Project	<b>IEEE 802.16 Broadband Wireless Access Working Group</b> < <a href="http://ieee802.org/16">http://ieee802.org/16</a> >	
Title	<b>Changes on Sleep Mode SDLs and MSCs</b>	
Date Submitted	<b>2004-01-15</b>	
Source(s)	Chulsik Yoon, Jaeheung Kim, Kunmin Yeo ETRI 161 Gajeong-Dong, Yuseong-Gu, Daejeon, Korea	Voice: +82-42-860-6826 Fax: +82-42-860-6732 mailto: <a href="mailto:csyoon@etri.re.kr">csyoon@etri.re.kr</a>
Re:	This is a response to a Call for Comments IEEE 802.16e-03/58 on IEEE 802.16e-03/07r5	
Abstract	This document contains suggestions to change the SDLs and MSCs reflecting working groups agreements on the Sleep Mode operation.	
Purpose	The document is submitted for review by 802.16e Working Group members.	
Notice	This document has been prepared to assist IEEE 802.16. It is offered as a basis for discussion and is not binding on the contributing individual(s) or organization(s). The material in this document is subject to change in form and content after further study. The contributor(s) reserve(s) the right to add, amend or withdraw material contained herein.

# Changes on Sleep Mode SDLs and MSCs

## 2. Proposed changes on Sleep Mode operation SDLs and MSCs in IEEE

Figure 108n – BS-SS Sleep Mode SDL Diagram

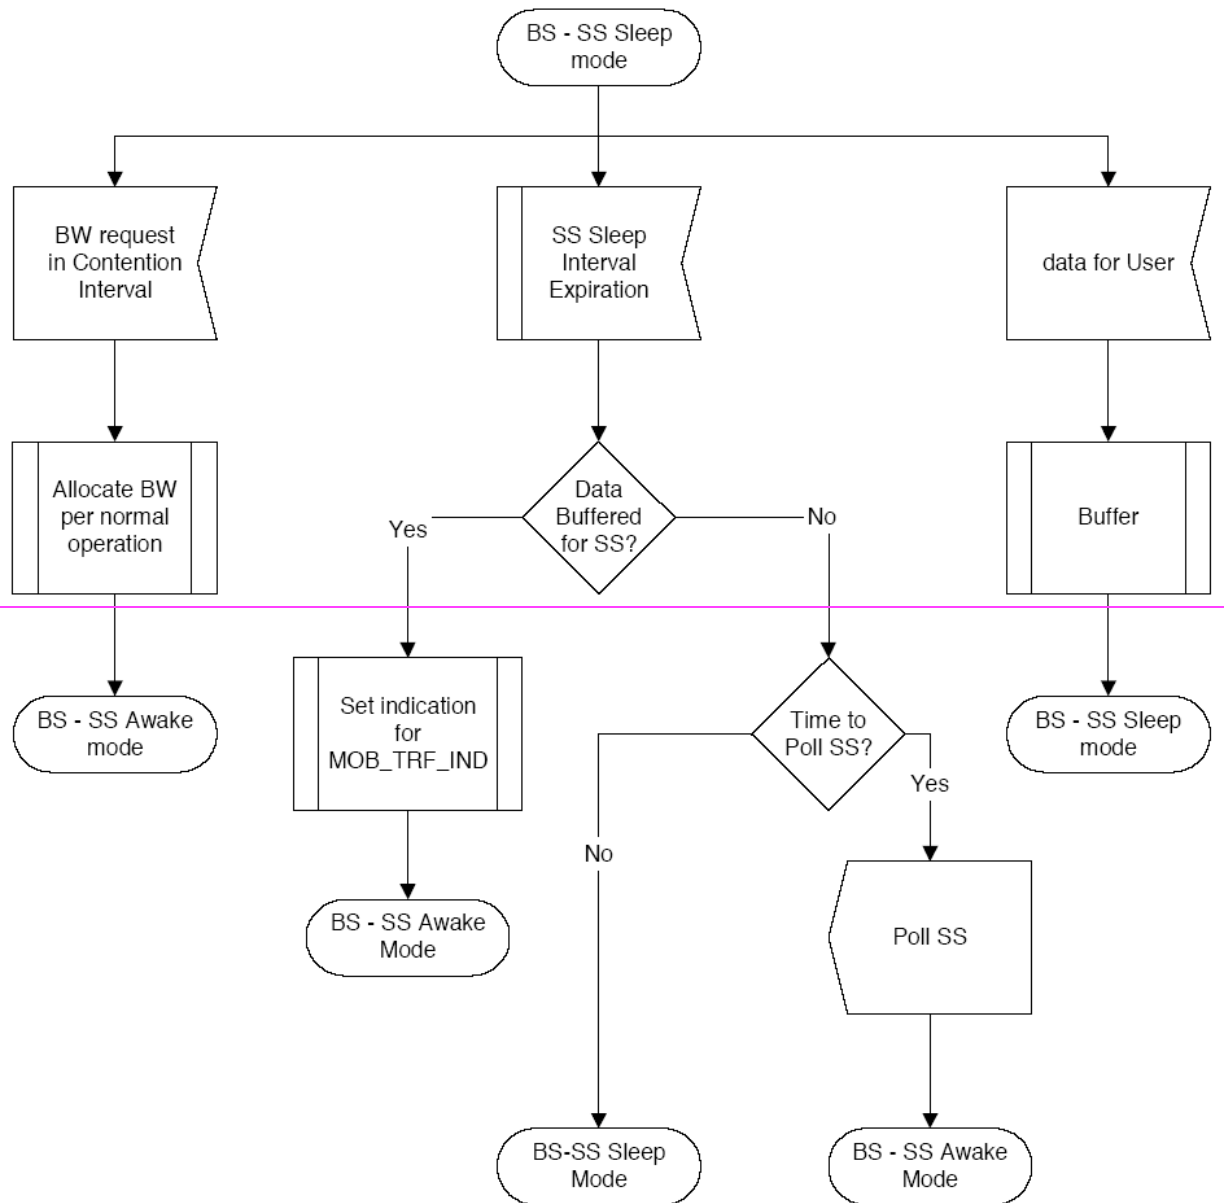
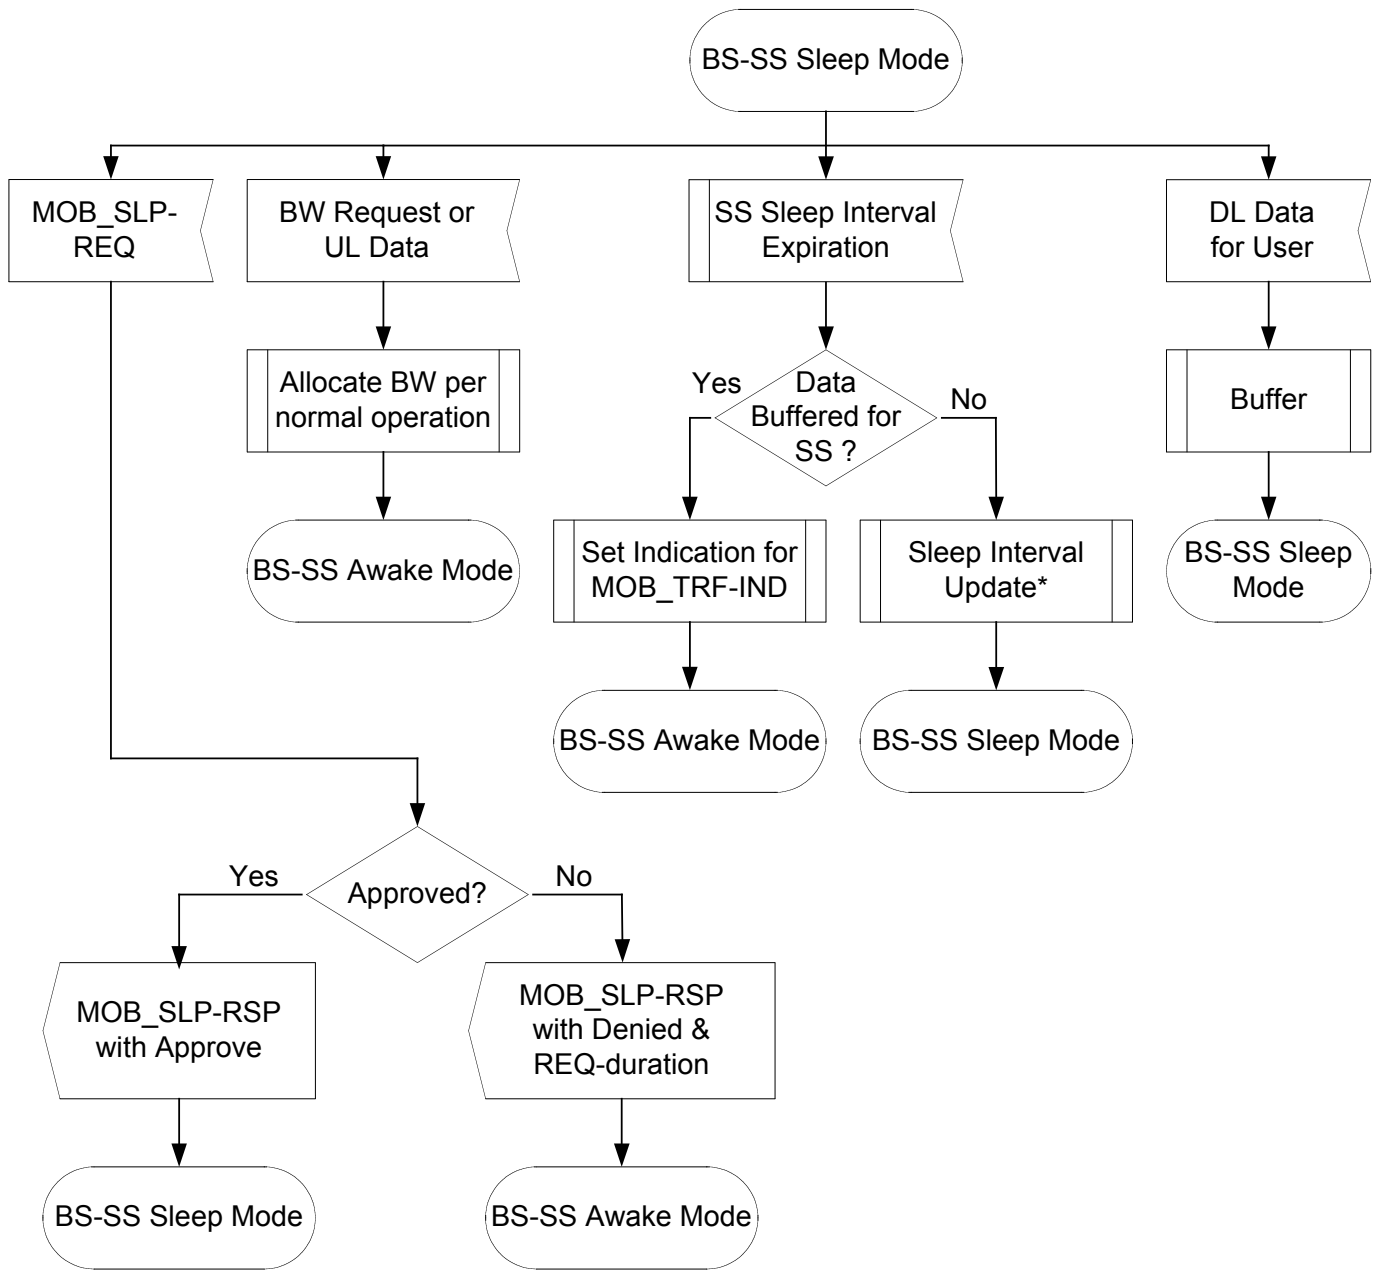
[Replace Figure 108n to the following:]  
 [From:]

~~Figure 108n - BS-SS Sleep Mode SDL Diagram~~

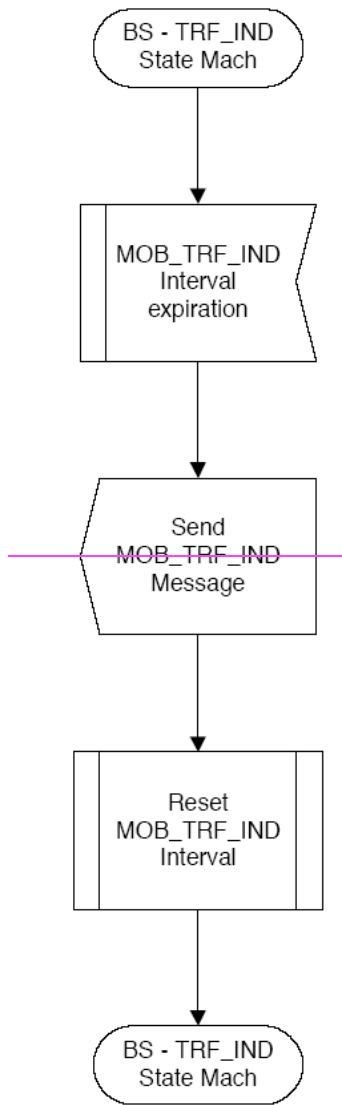
*[Delete Figure 108o:]*

Figure D.11 – Sleep Mode – MSS initiated

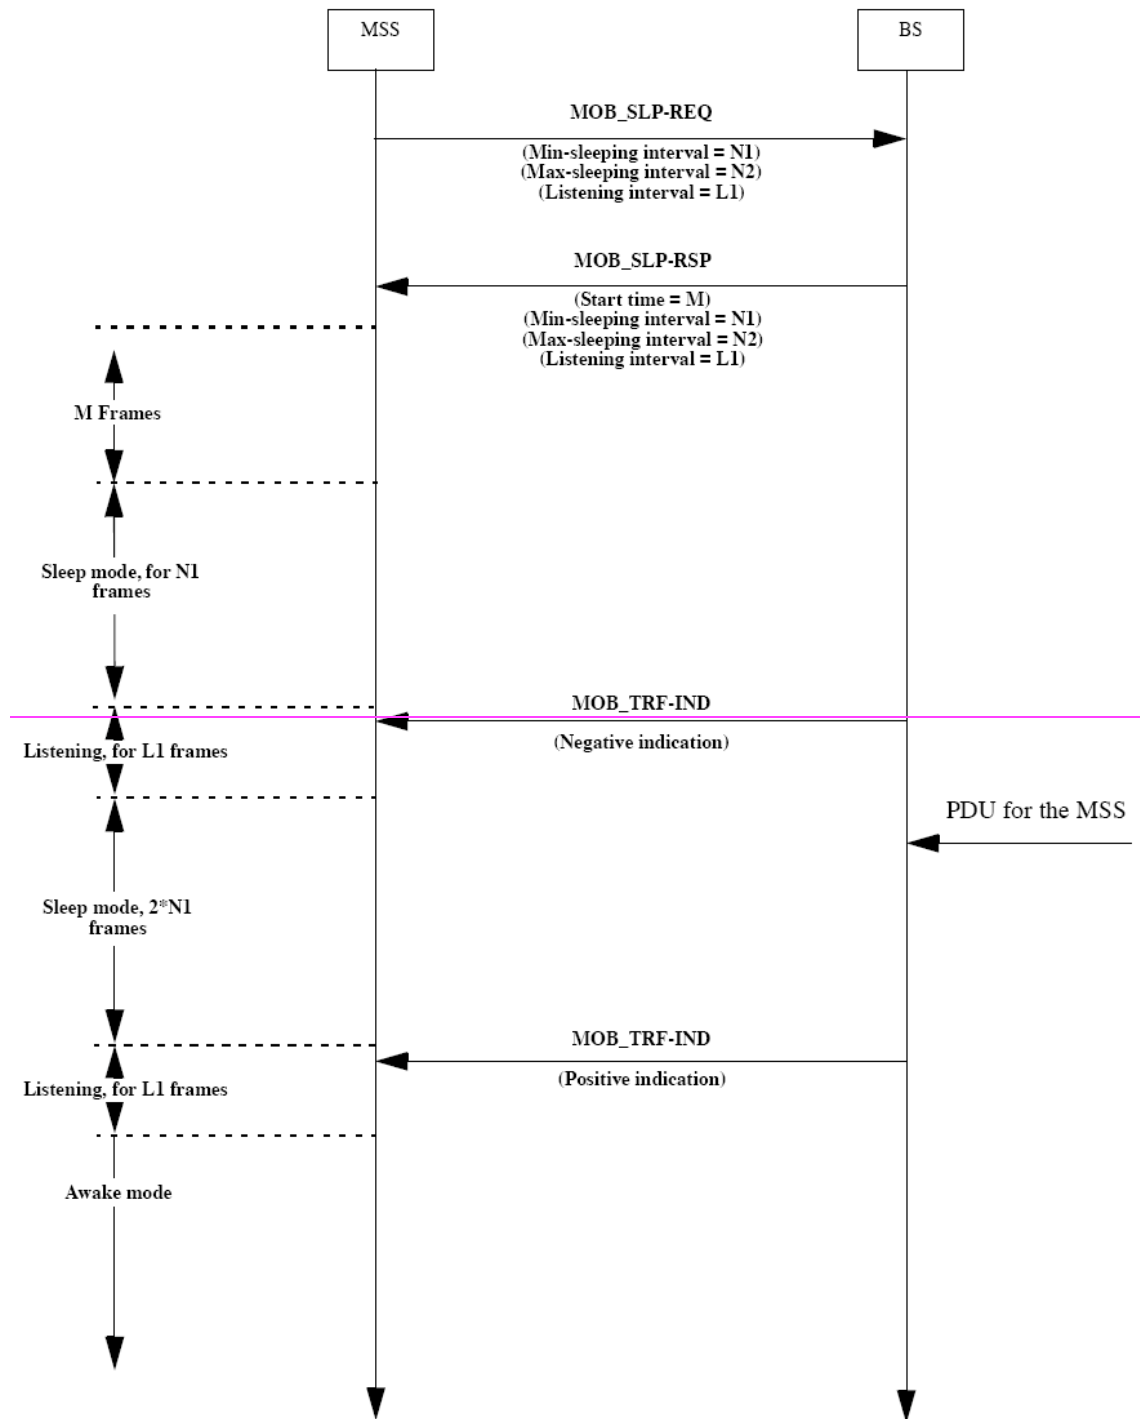
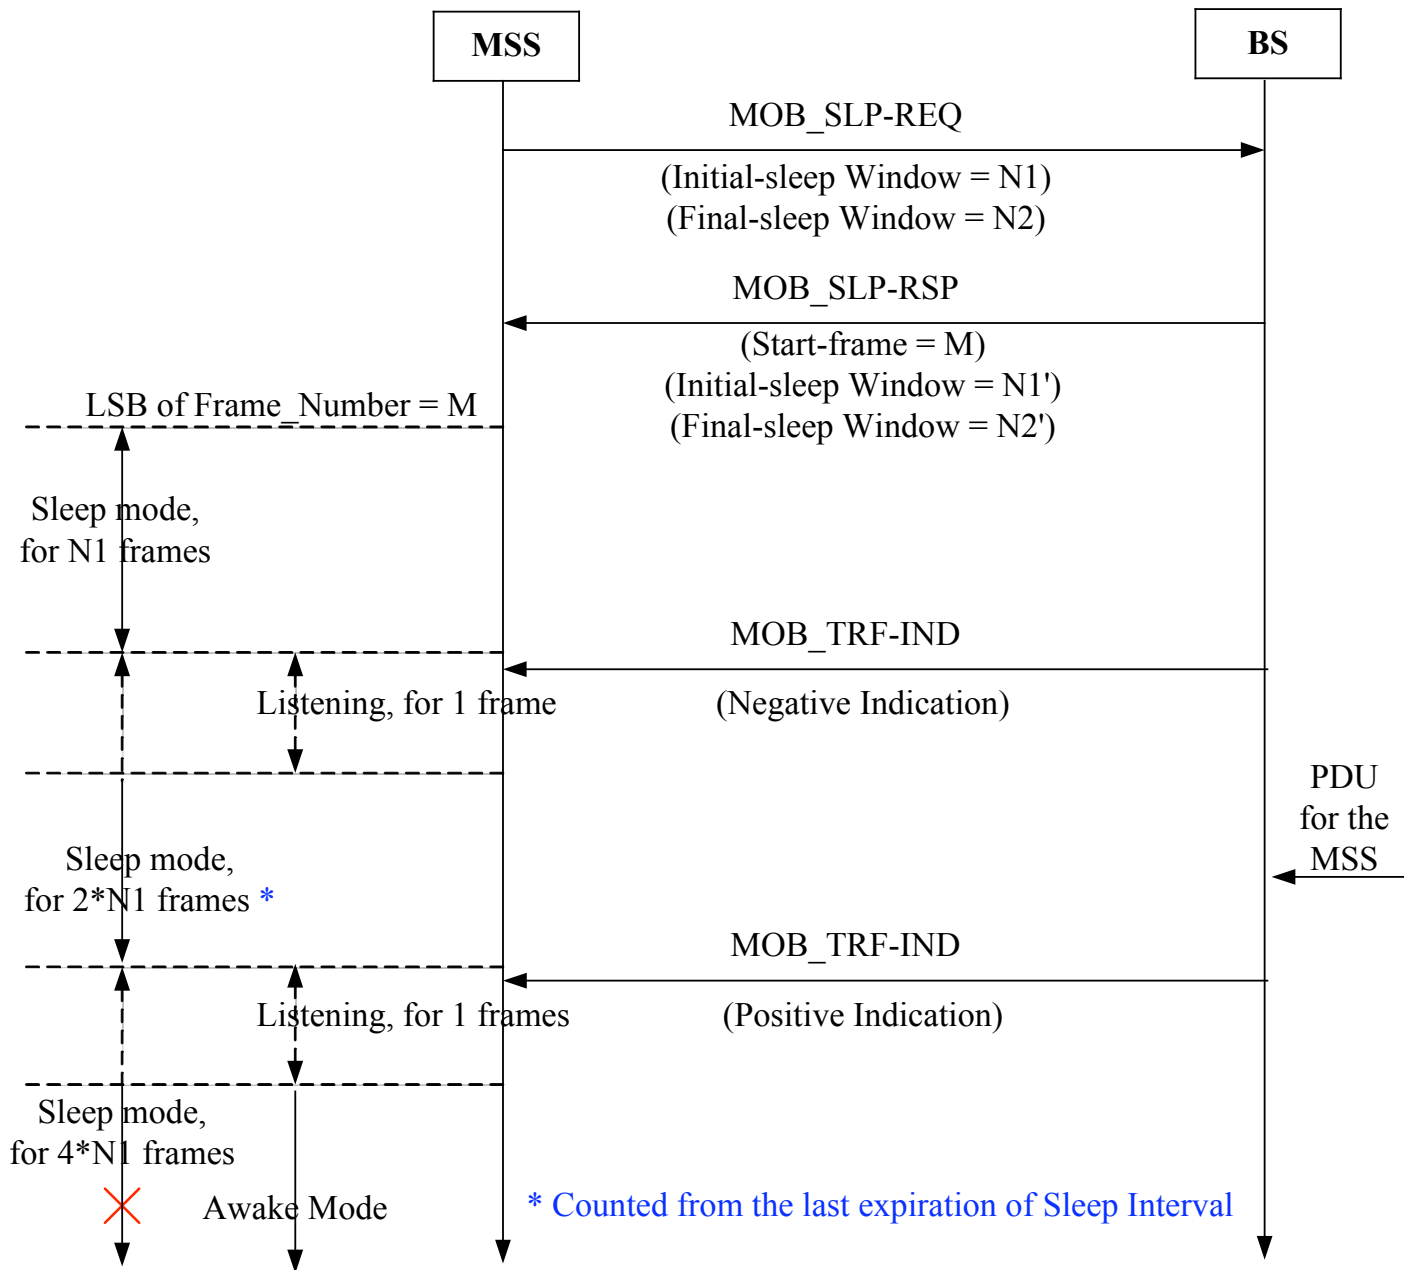
[Replace Annex D.2 Figure D.11 to the following:]  
 [From:]

Figure D.12 – Sleep Mode – BS initiated

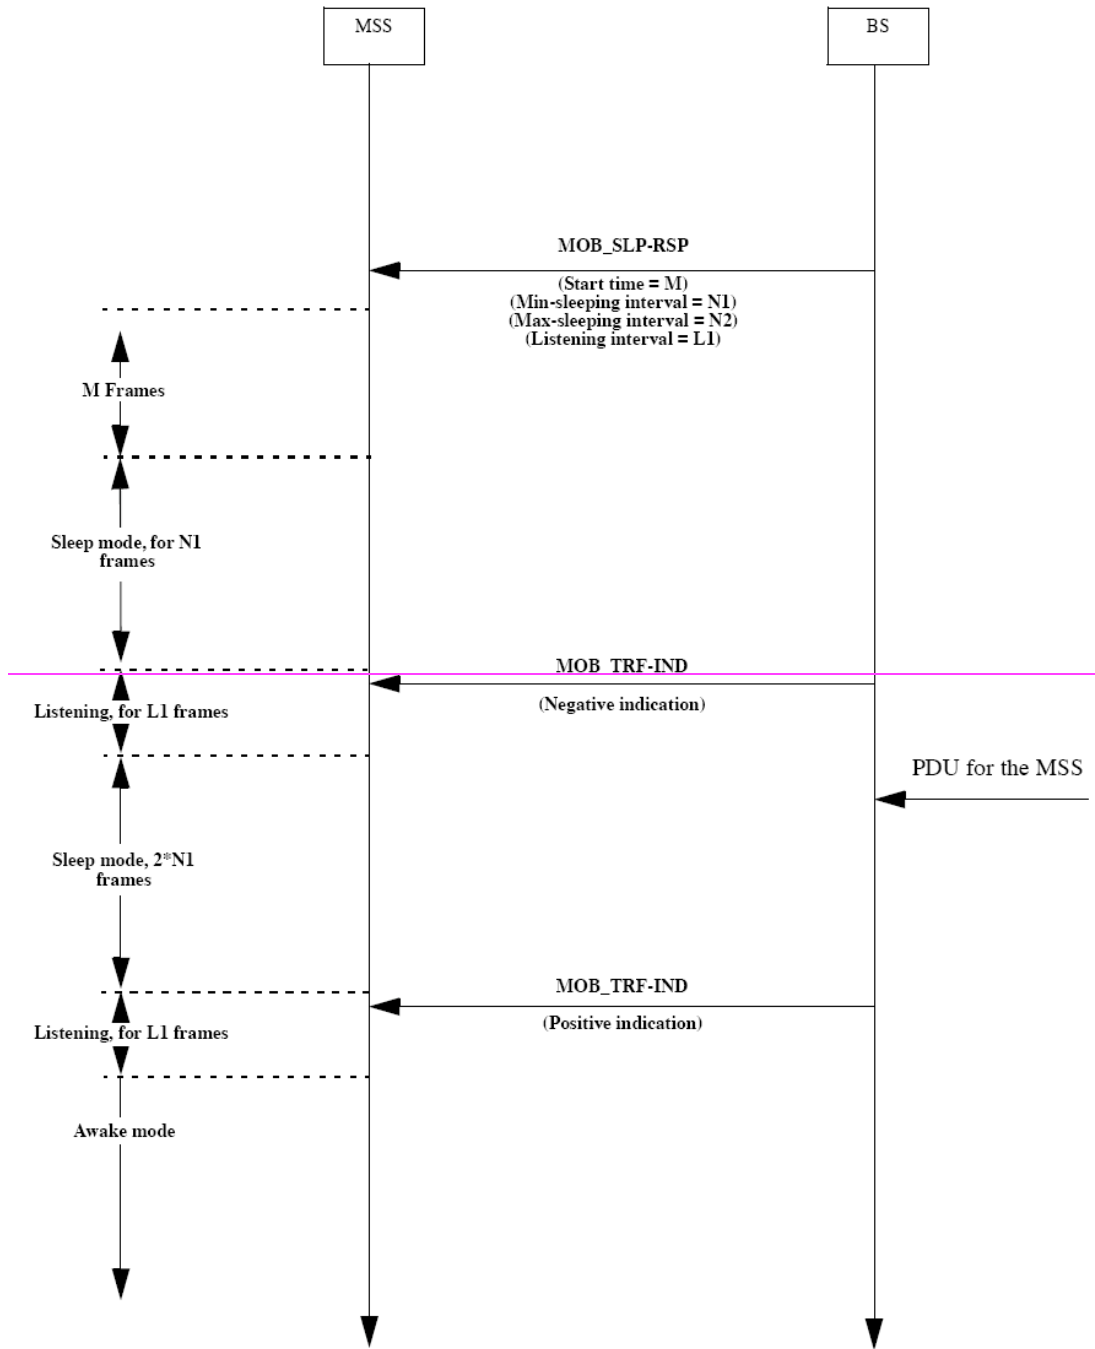
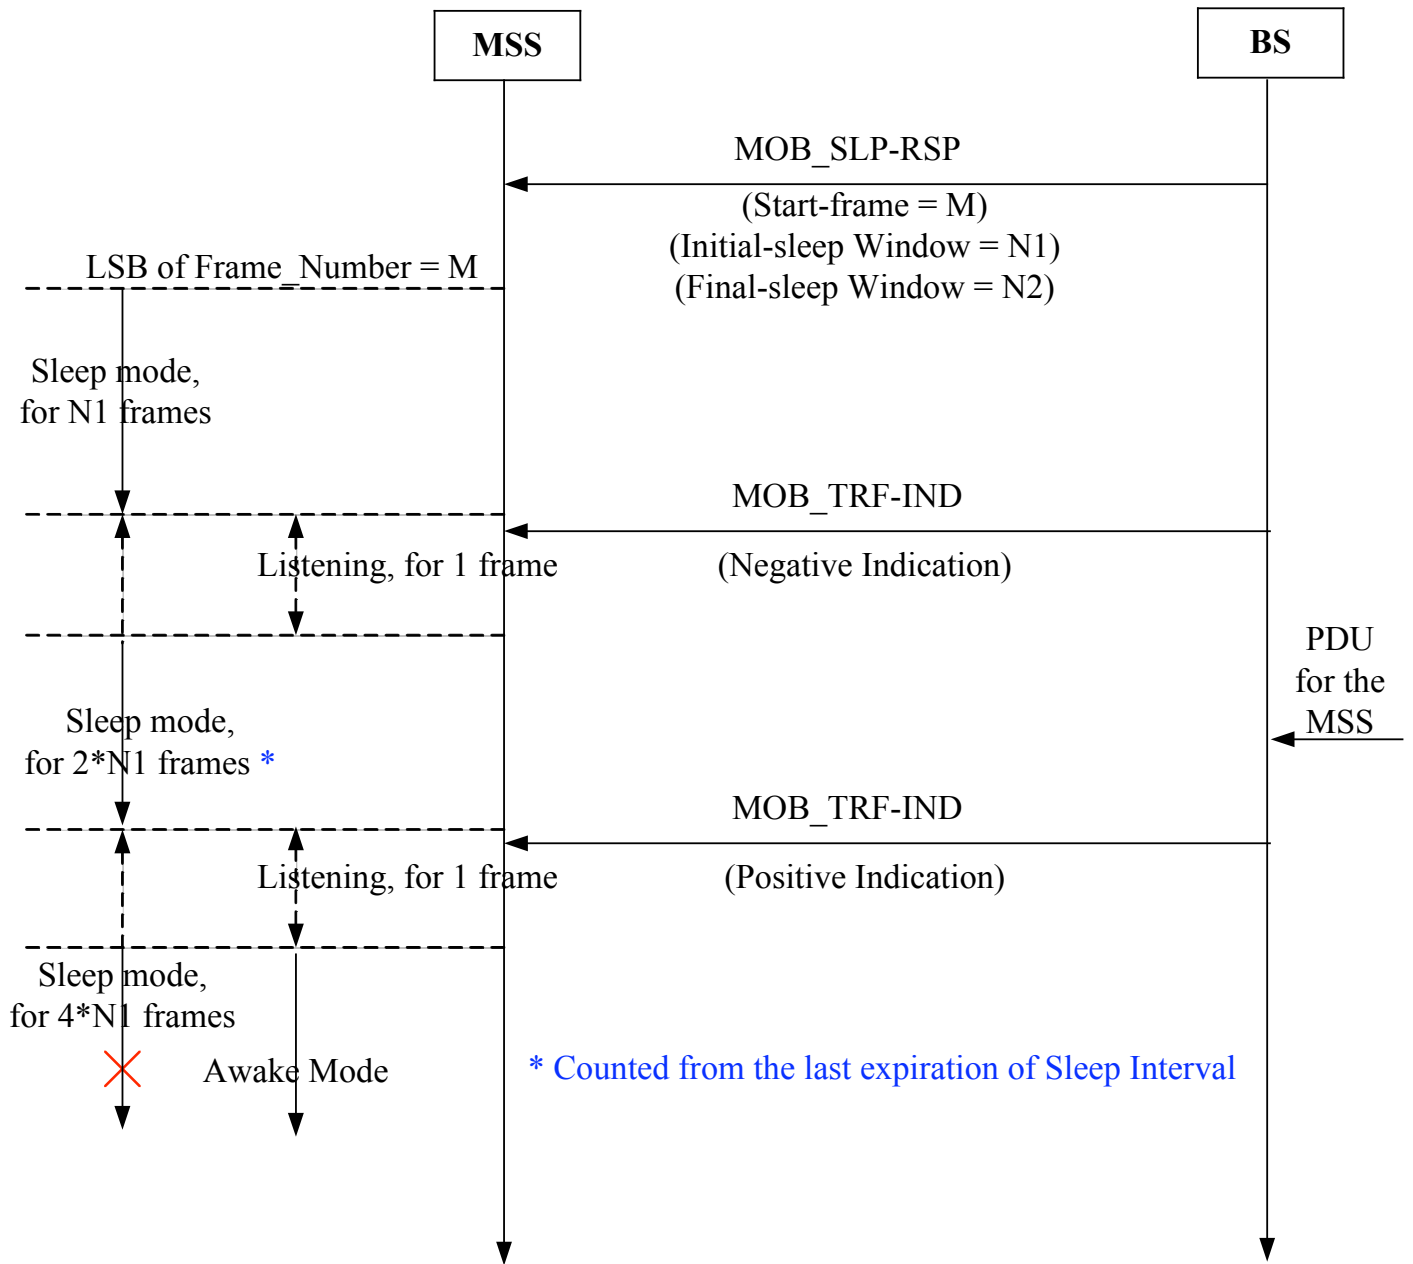
[Replace Annex D.2 Figure D.12 to the following:]  
[From:]
